DESIGN CHANGES

Project Name	County Flats, Sandfields
Project Ref	OAD_5174
Drawing Ref	1241
Drawing Name	Flat Type For Third Floor
Drawn By	WS
Date	21.04.2021

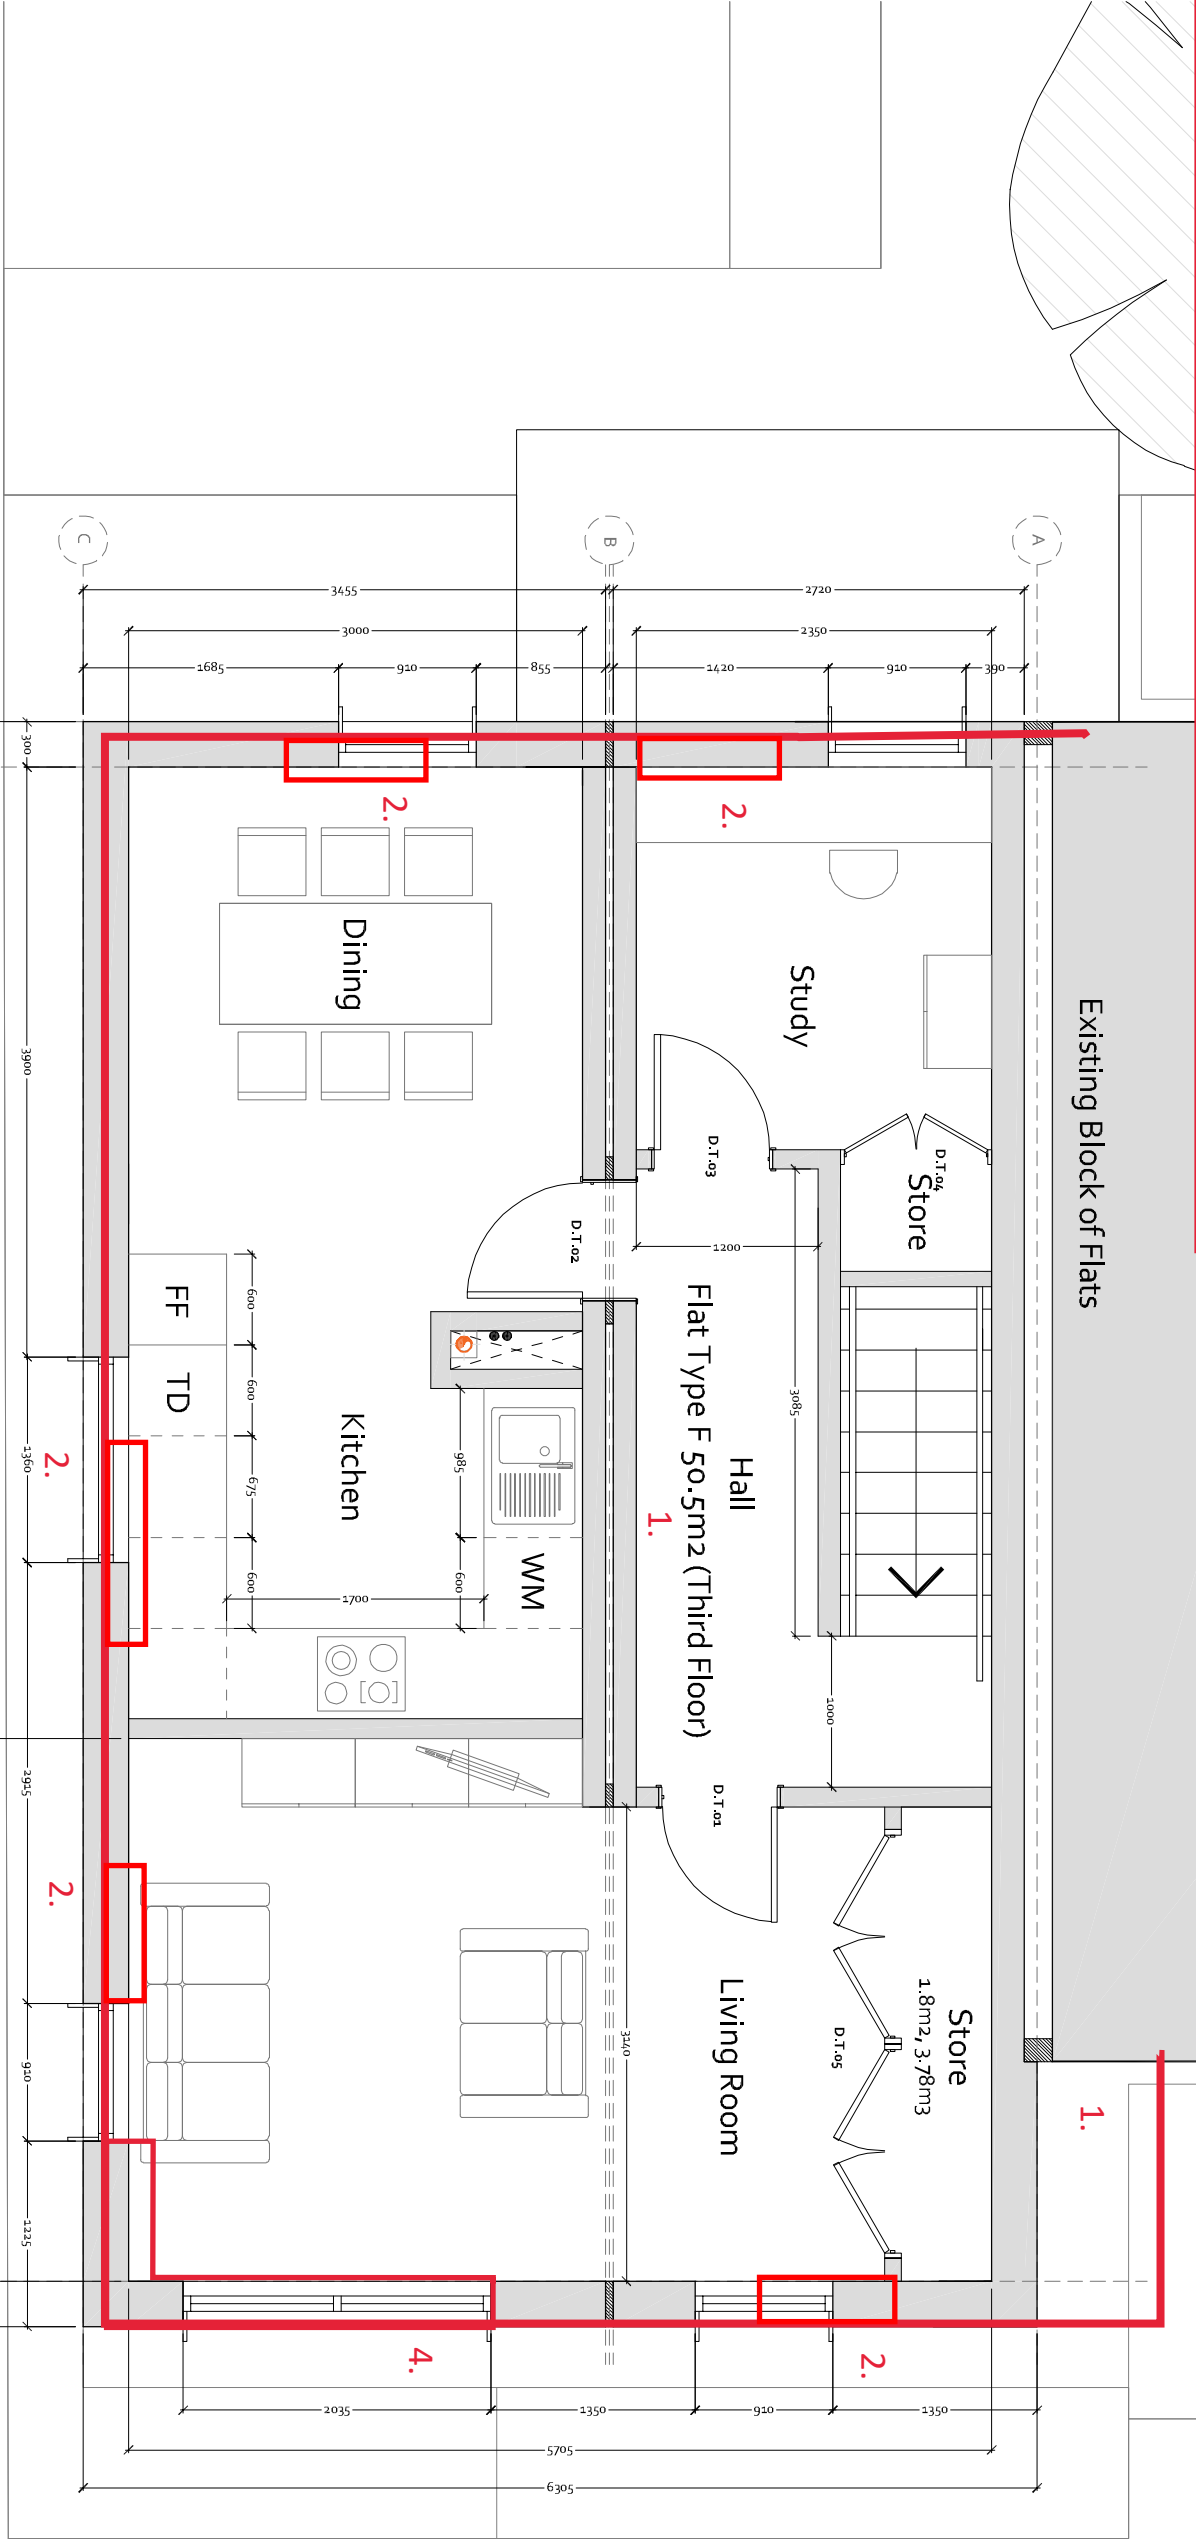
1. Modular end links re-positioned slightly off existing buildings, with the party wall straightened and porch projections aligned with this wall, to ensure modular construction can be achieved off site.
2. Windows have been slightly re-positioned to the new build to suit the structural design of the modular units and the constraints of the timber frame.
3. Parapet to modular end blocks have been lowered by approx 900mm to comply with the structural wind loadings and timber frame design.
4. Corner windows have been removed and replaced with 2no. Windows on either corner, again due to the structural and timber frame design of the blocks.
5. PV panels have been omitted from the end modular units to suit the structural and timber frame design of the blocks.

6. Ground floor Juliet balcony added to existing flats to provide better security whilst ensuring the open areas remain as communal spaces.
7. Air source heat pump external louvre enclosure amended to be single storey over entrance canopy to end link blocks.

8. External air source louvered enclosure handed to provide internal riser/access requirements for maintenance.
9. Buggy/cycle store added to block 6 and 7 parking courtyards.

10. Bin stores slightly re-positioned to suit existing drainage runs, with bin store near block 6 amended in size to suit located of bedroom window.
11. Footpaths amended to be Tarmac.

12. Windows in communal area to the linked blocks made narrower to ensure 1.8m fire separation distance to existing windows is achieved to comply with building regulations.

13. 1no. window in block 7 communal area either side of stairwell removed to ensure 1.8m fire separation distance to existing windows is achieved to comply with building regulations.
